Lee's Summit Missouri
Development Services
ATTN: Joe Frogge
Carhartt – Lee's Summit
1744 NW Chipman Rd., Lee's Summit, MO 64081
Permit Number: PRCOM20252521

Please see below for responses to permit comments.

STRUCTURAL CALCULATIONS
UNIT ANALYSIS

EXISTING FRAMING PLAN

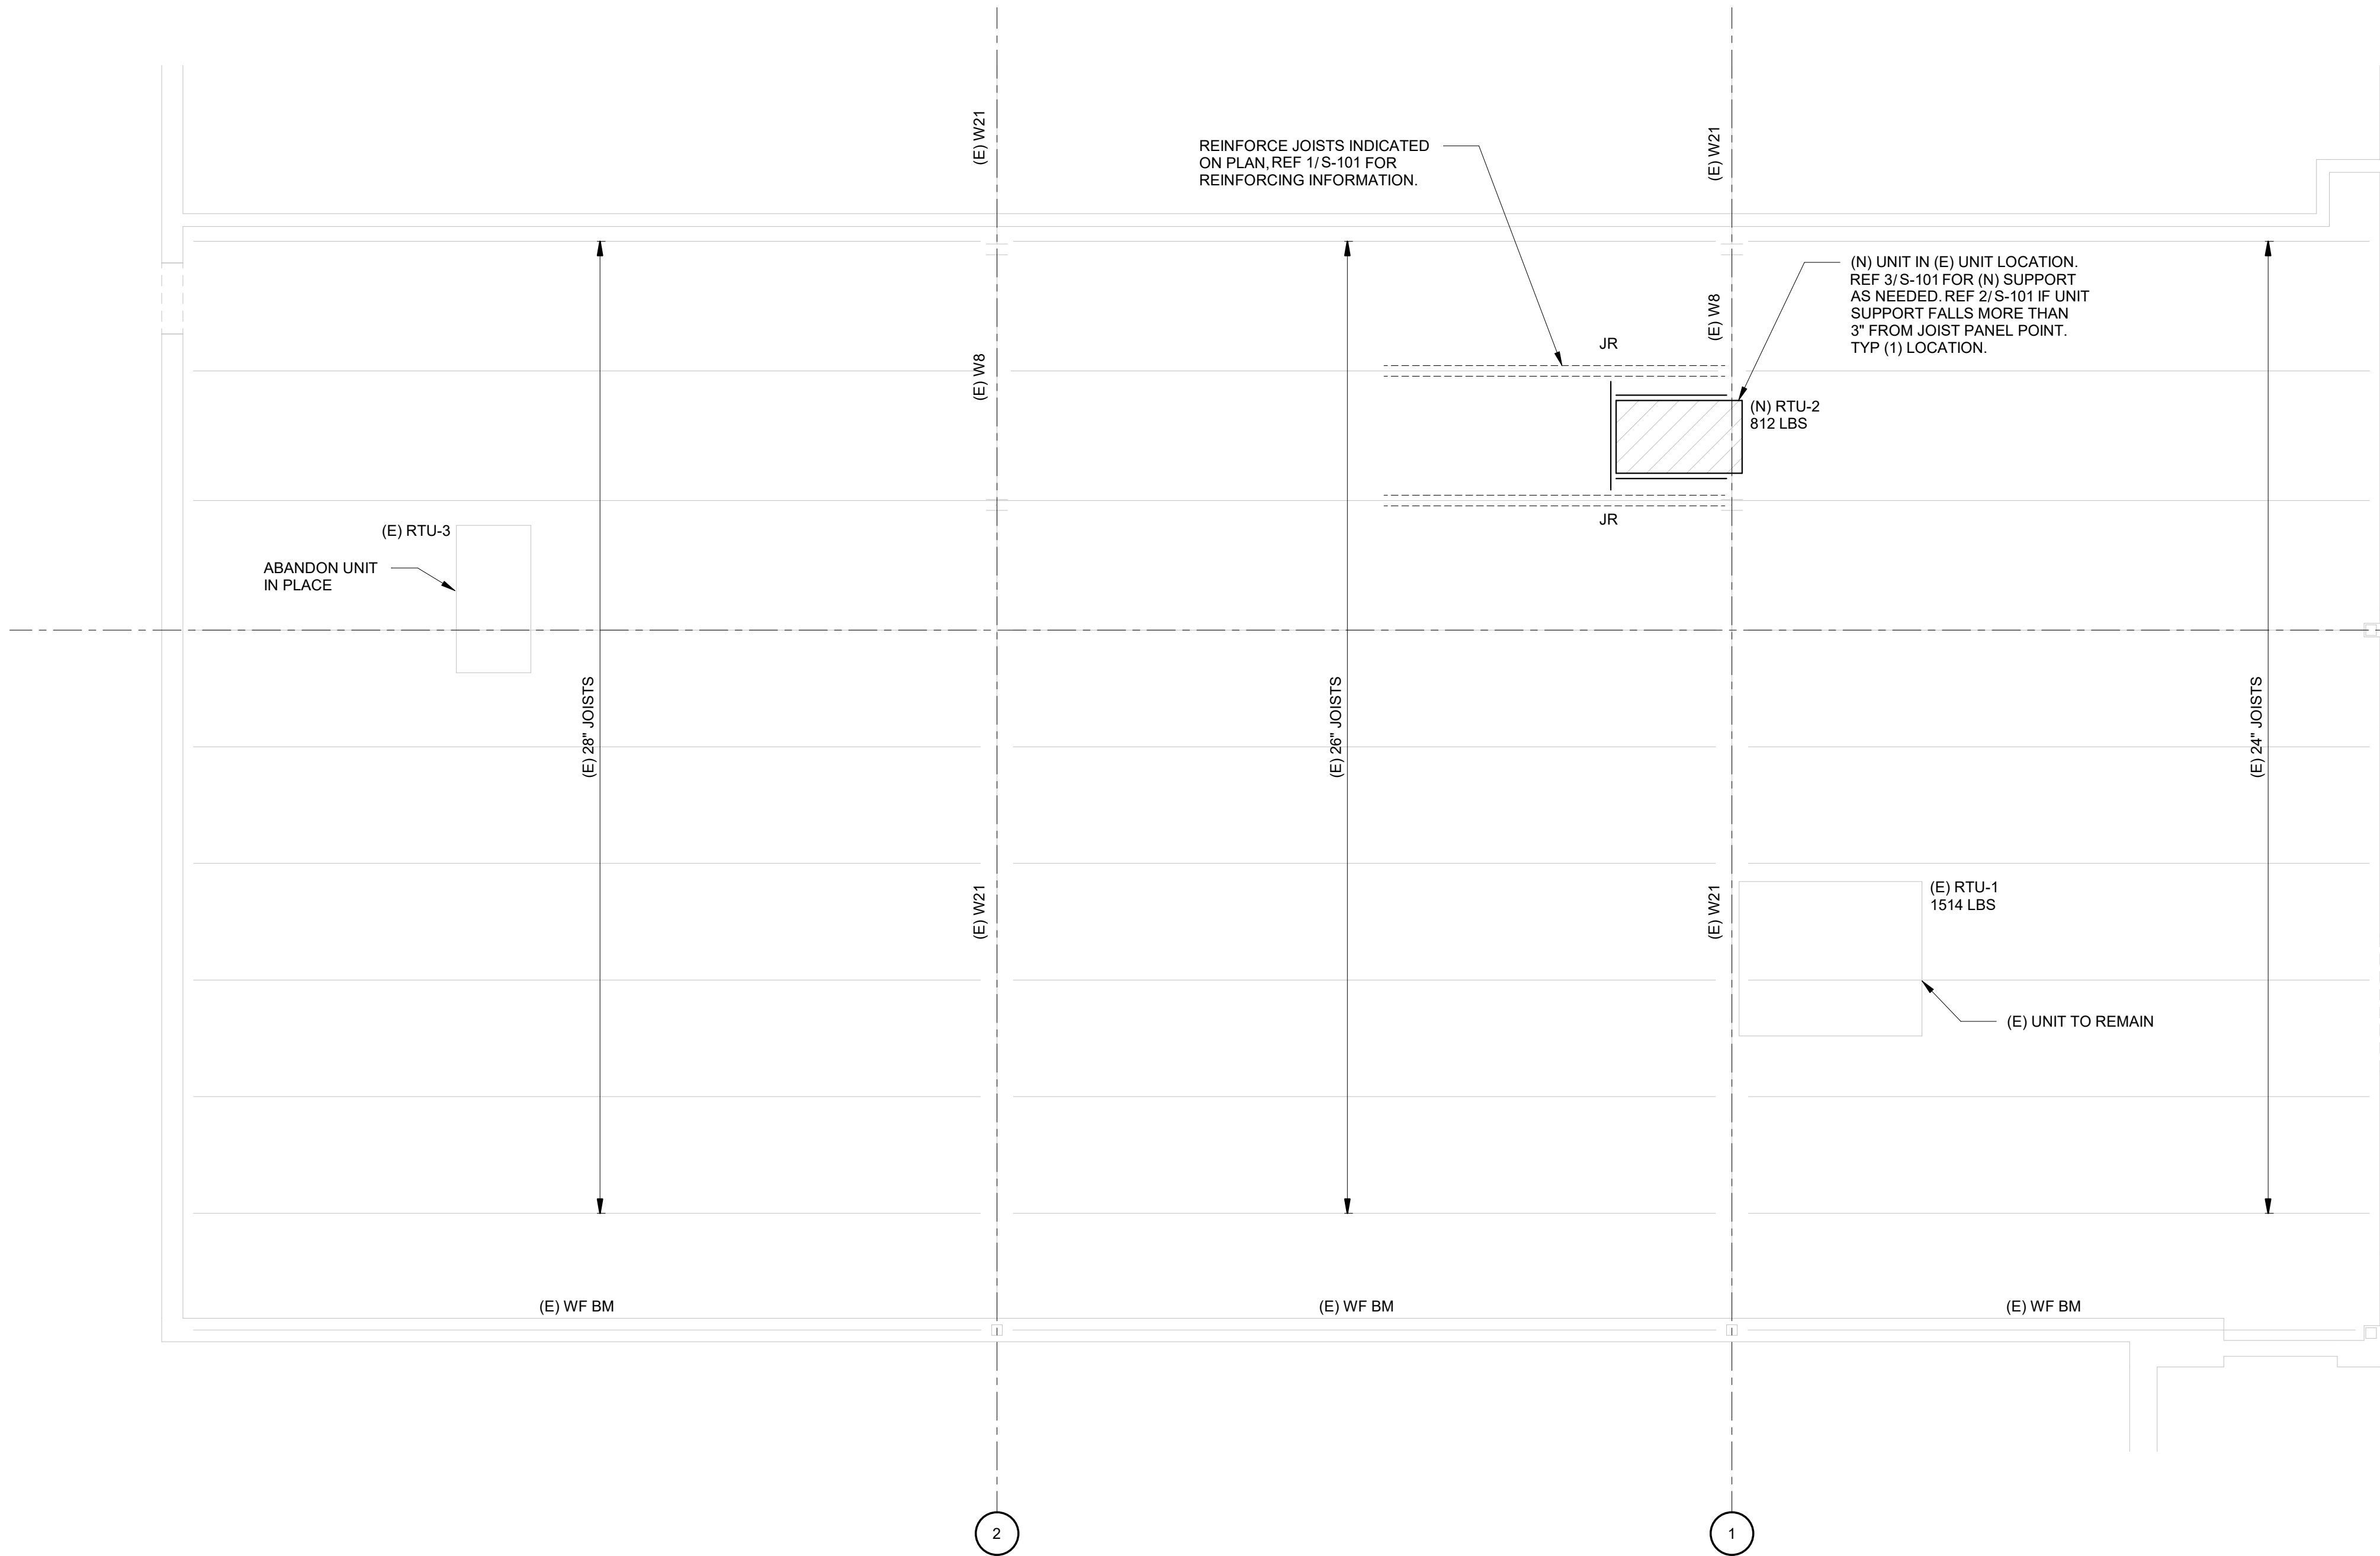
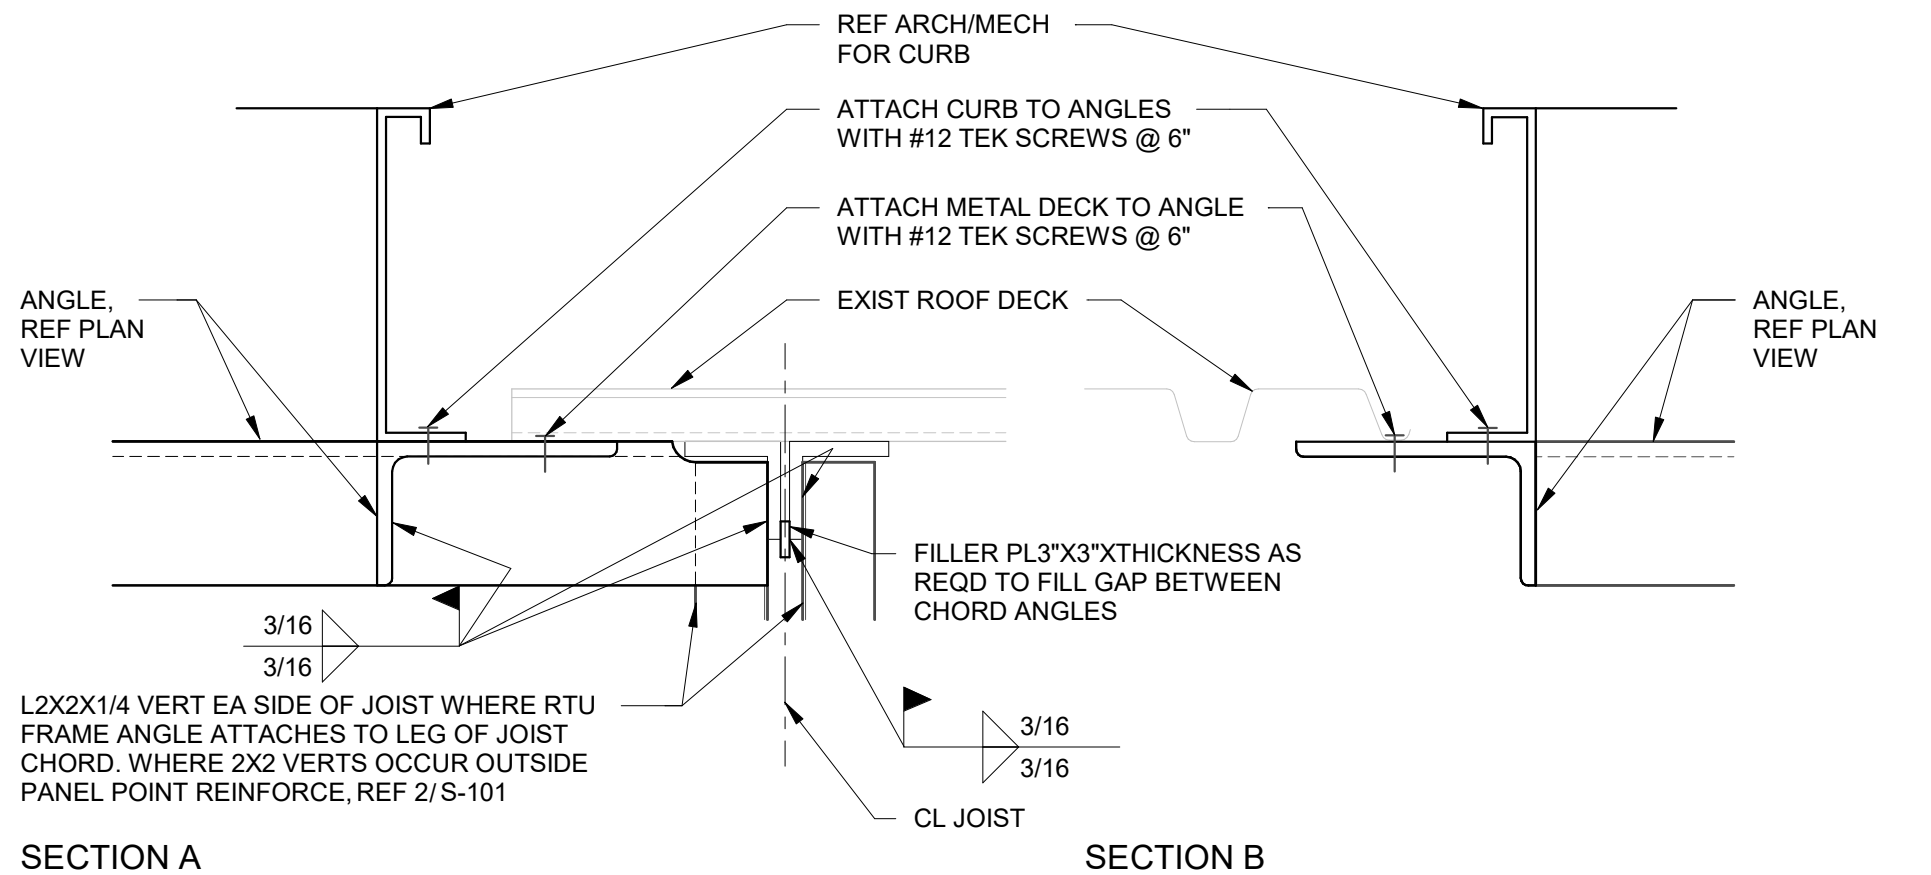
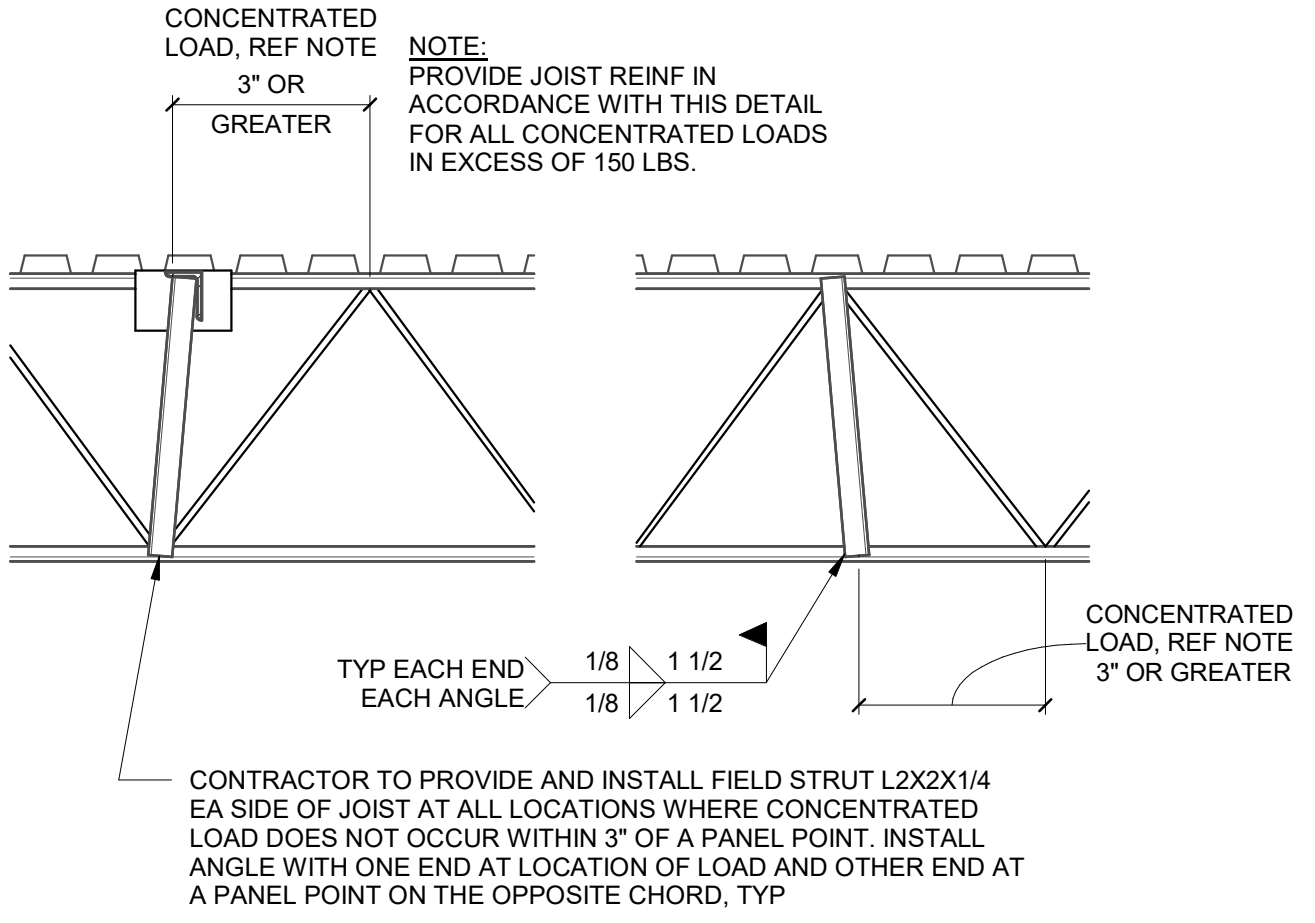
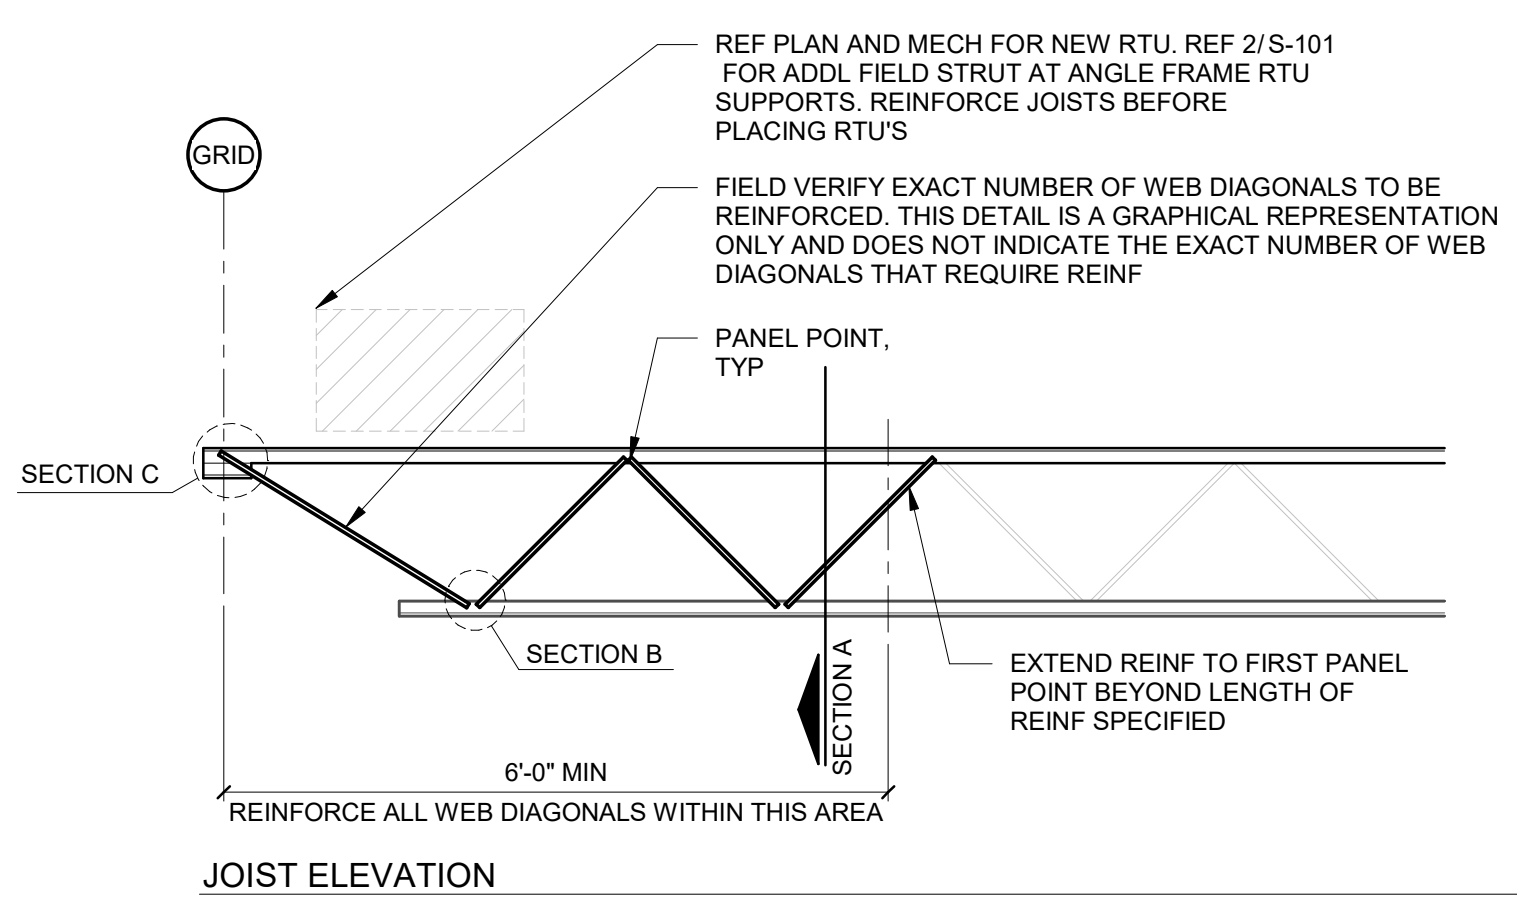
| Comment ID | Review Comment | Response |
|------------|---|---|
| 2 | 2018 IBC 1606.2 Design dead load. For purposes of design, the actual weights of materials of construction and fixed service equipment shall be used. In the absence of definite information, values used shall be subject to the approval of the building official. Action Required: Provide verification that either the weight of new roof top equipment is less than or equal to original equipment or provide engineer's report to verify that existing roof structure will support additional load. | Sheet S100 and S101 as well as signed/stamped structural calculations provided to accommodate new roof top equipment. |
